平陆县 100MW 农光互补光伏发电项目
监理工程师通知单

编号: ZHJL-JLTZ-PL-190

主题: 2025 年 3 月 22 日建设单位、监理单位及总包单位在新西沟地块 33 区验收过程中发现以下问题:

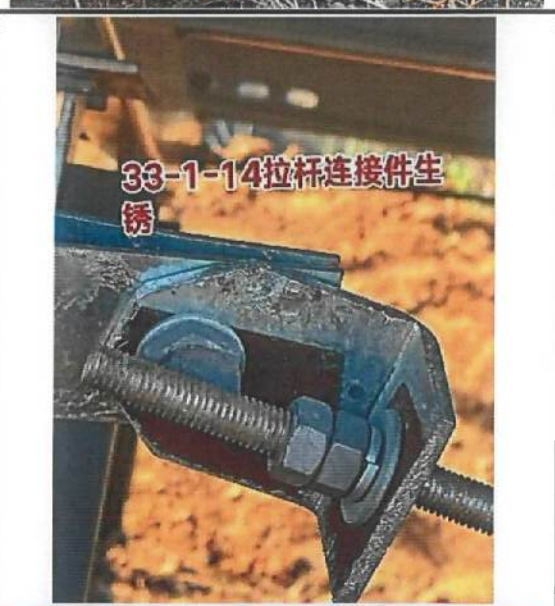
21	 33-4-16缺少两个对穿螺栓	22	 33-4-1缺少两个对穿螺栓
23	 33-4-1缺少对穿螺栓	24	 33-4-3缺少对穿螺栓
25	 33-4-5檩条连接件缺少弹垫	26	 33-4-19缺少对穿螺栓
27	 33-3-2电缆敷设不规范	28	 33-3-8需要更换长拉杆

请贵单位按照上述问题立即消缺整改。

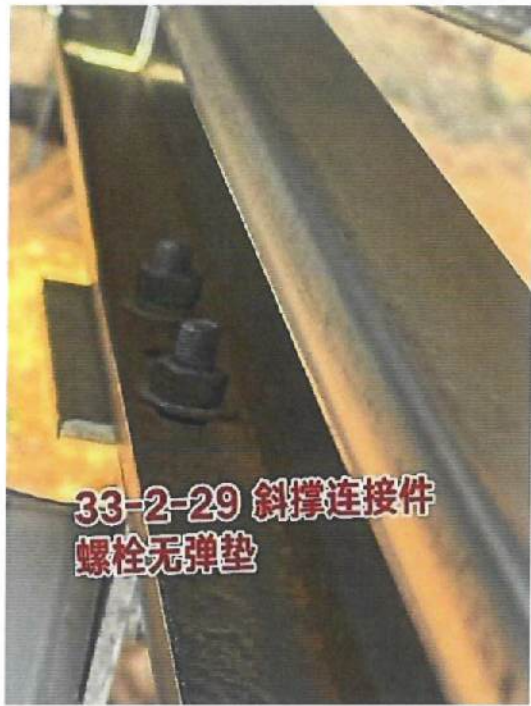
29	 33-3-3 电缆敷设不规范	30	 33-3-12 压块与组件间隙大
31	 33-3-8 电缆敷设不规范	32	 33-3-17 压块缺少螺母
33	 33-3-17 压块组件间有间隙	34	 33-3-17 mc4 插头未固定
35	 33-3-19 压块垫片错位	36	 33-3-17 四平方电缆敷设不到位

37	 33-3-20mc4插头未固定	38	 33-3-24mc4插头未固定
39	 33-6-36多个压块螺丝固定	40	 33-6-22缺对穿螺丝
41	 33-5-21缺对穿螺丝	42	 33-6-17缺对穿螺丝
43	 33-8-21 1个压块一块压板未固定	44	 33-6-15缺对穿螺丝
